PLANNING AND DEVELOPMENT SERVICES STAFF REPORT

For Planning Commission Meeting of July 7, 2015

SUBJECT: Rockbridge Hotel & Retail Rezoning and Planned Project Site Plan

File Nos. SP15-012 & Z15-003

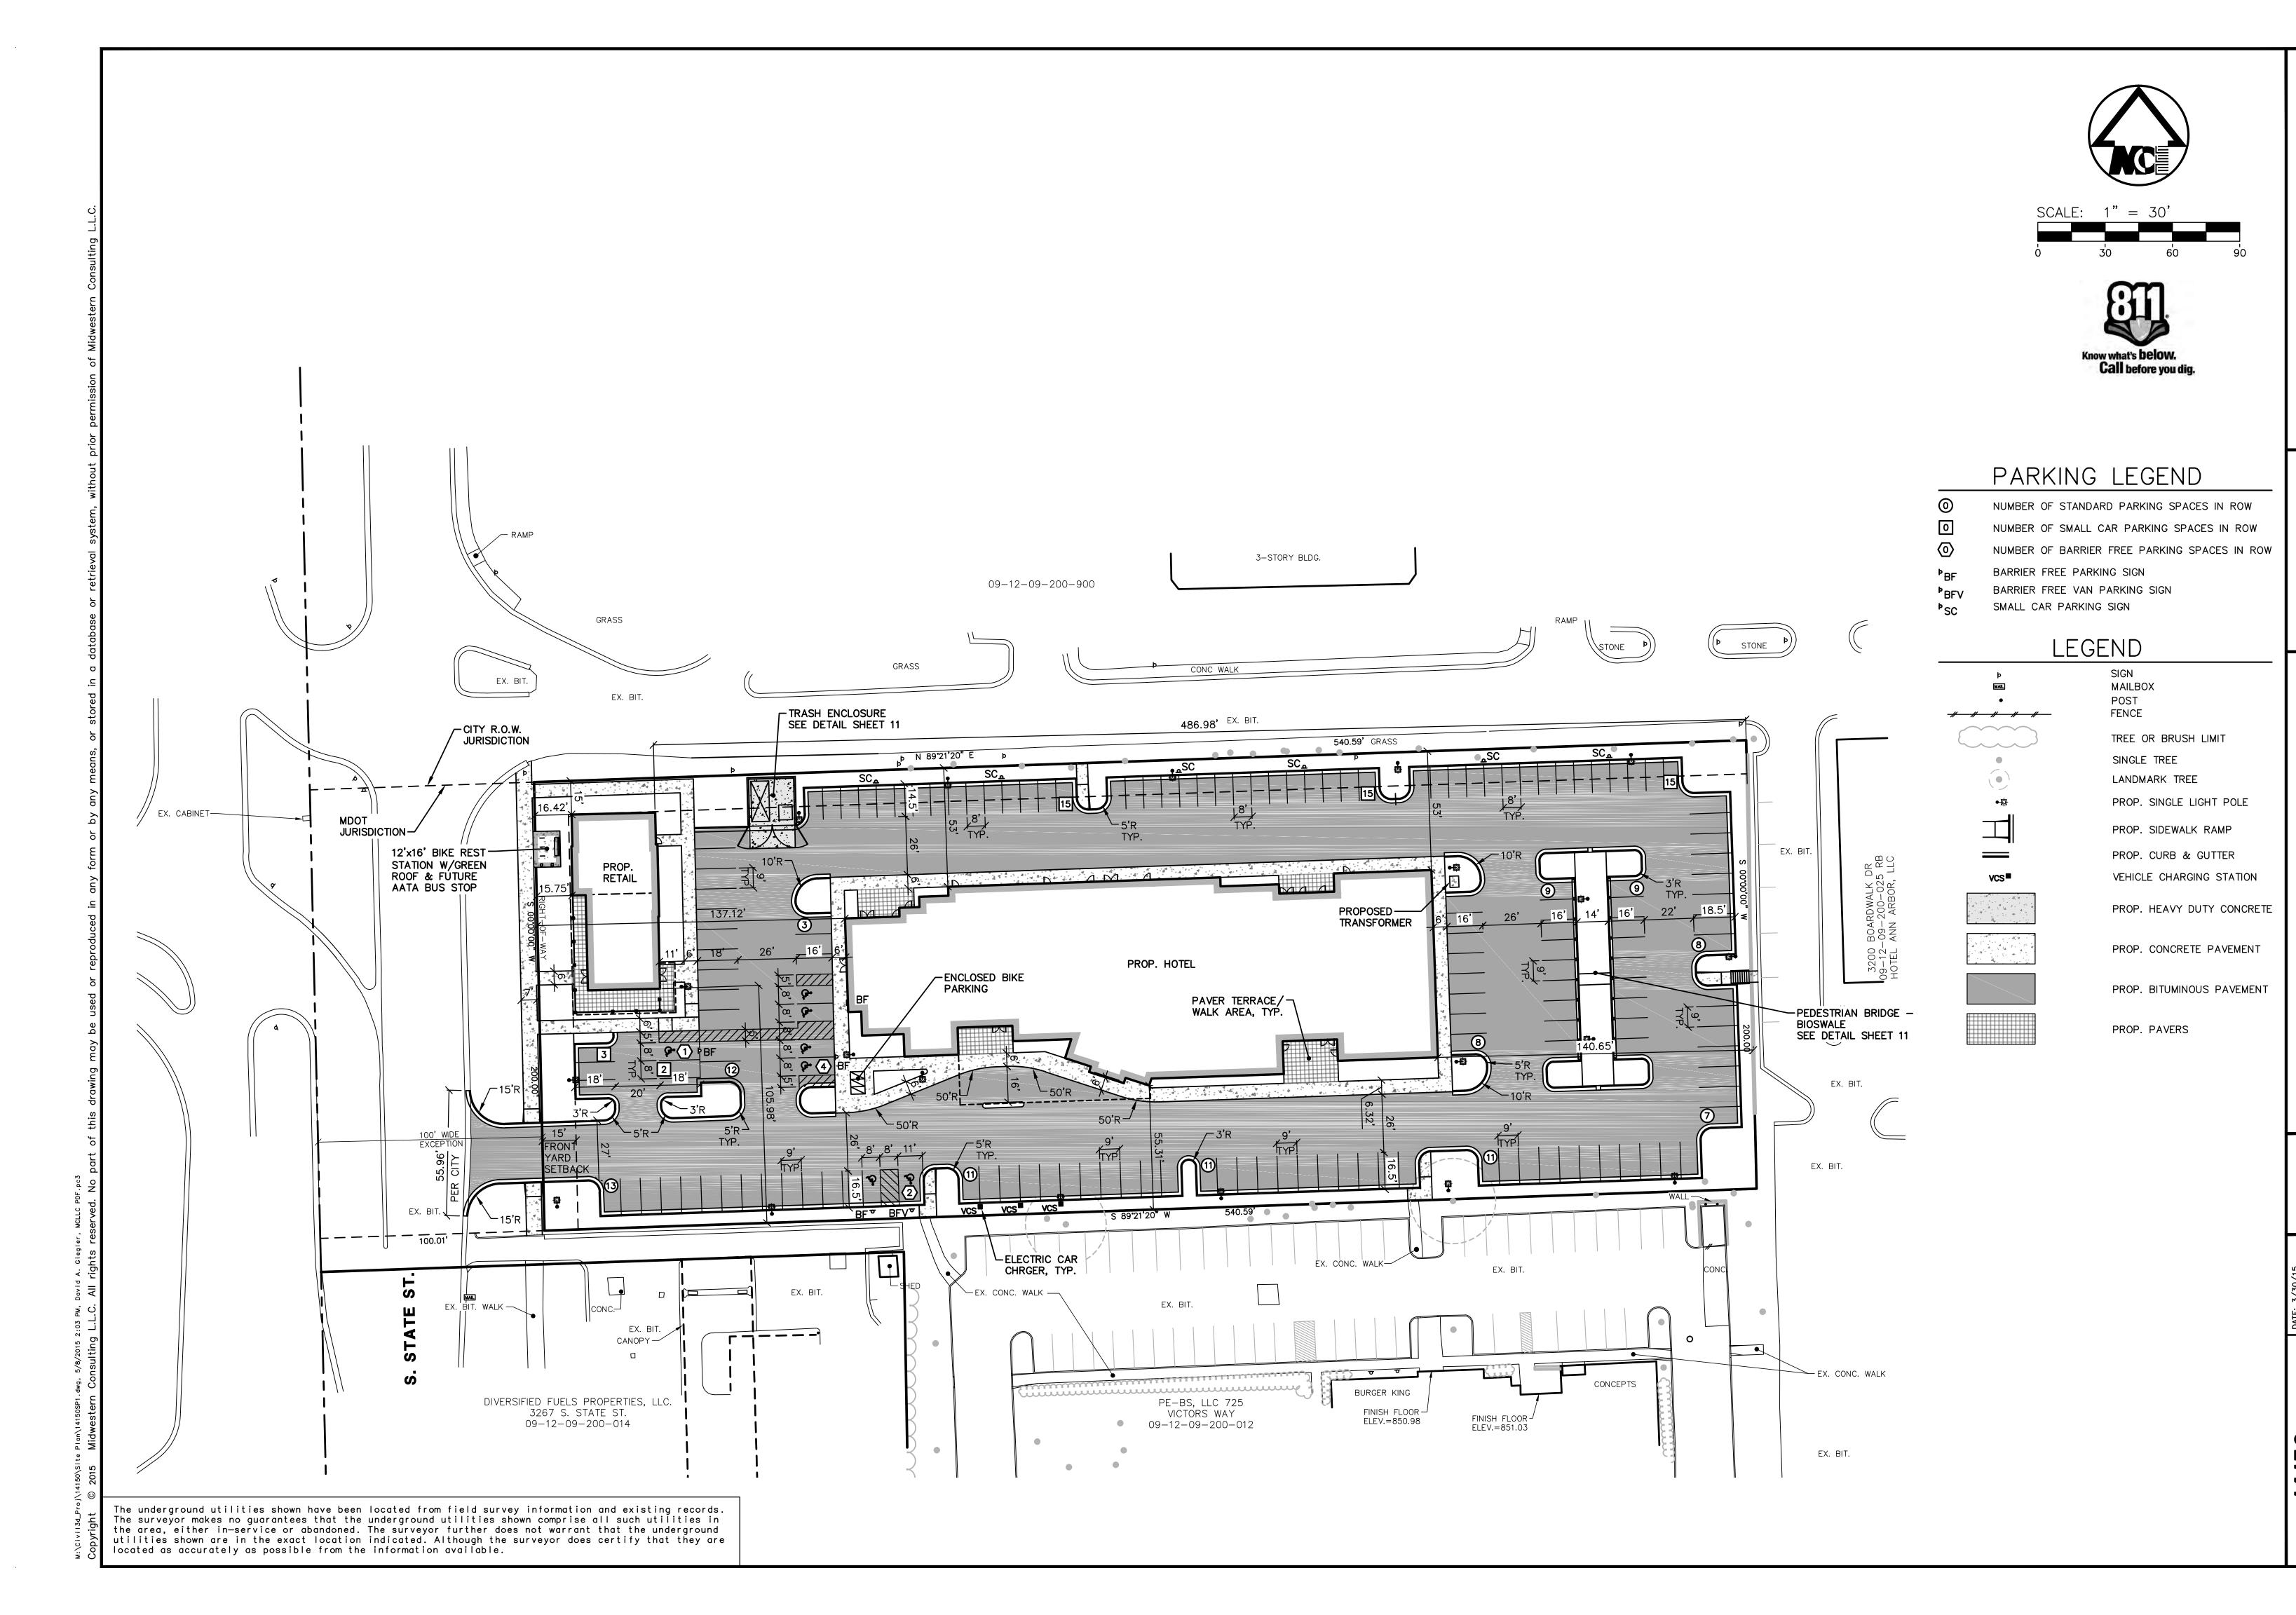
Sidewalk Installation

The sidewalk along the south side of the service drive fronting this site does not currently exist. The petitioner reduced the parking aisle width and installed a six-foot wide sidewalk along the service drive. Two additional non-landmark trees are proposed to be removed for the sidewalk installation. No mitigation is required for their removal.

The <u>Non-Motorized Plan</u> and <u>South State Street Corridor Plan</u> recommend sidewalks on both sides of the service drive. The petitioner proposes a sidewalk along their service drive frontage and connected this site with the site to the south which improves traffic circulation.

SITE PLAN AND DIAGRAM | BIKE SHELTER/BUS STOP

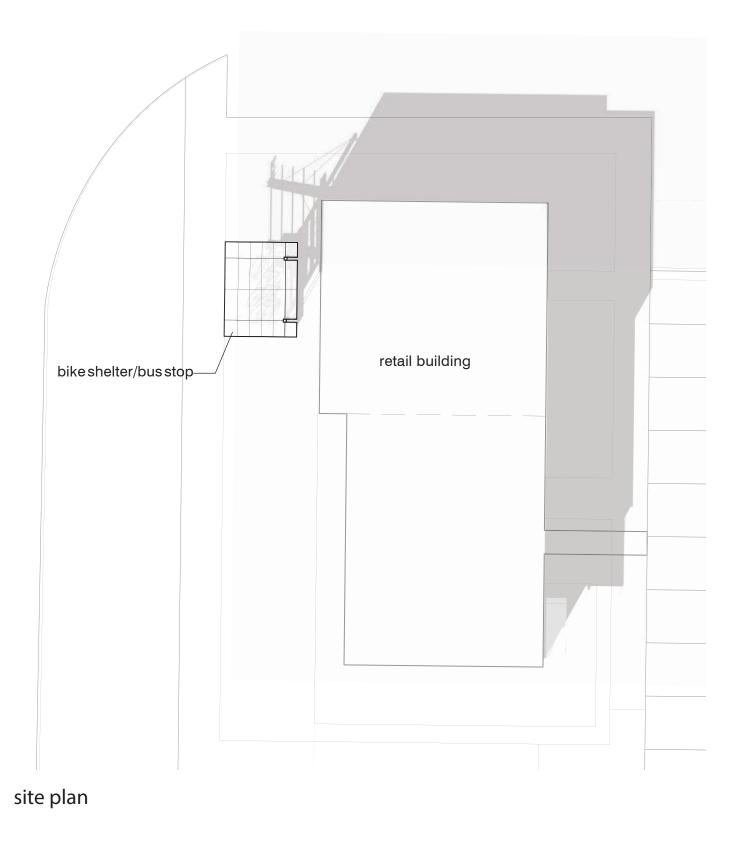
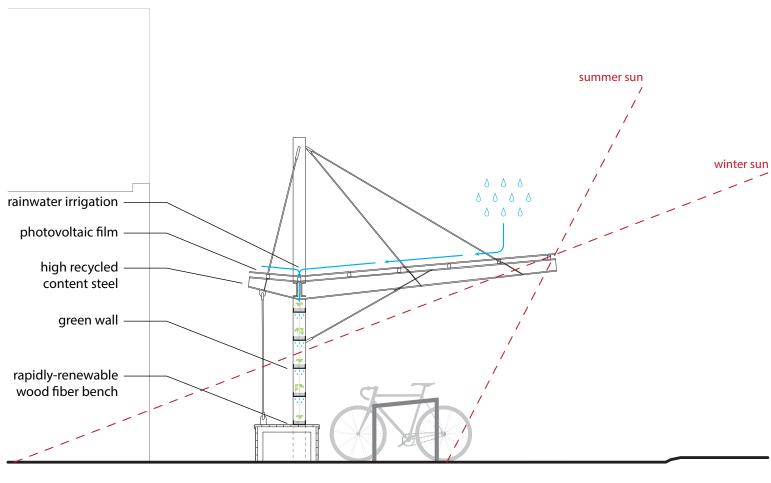
The bike/bus rest area has been revised to be more architecturally consistent with the site buildings, and the roof has been modified to show solar panels instead of green vegetation.
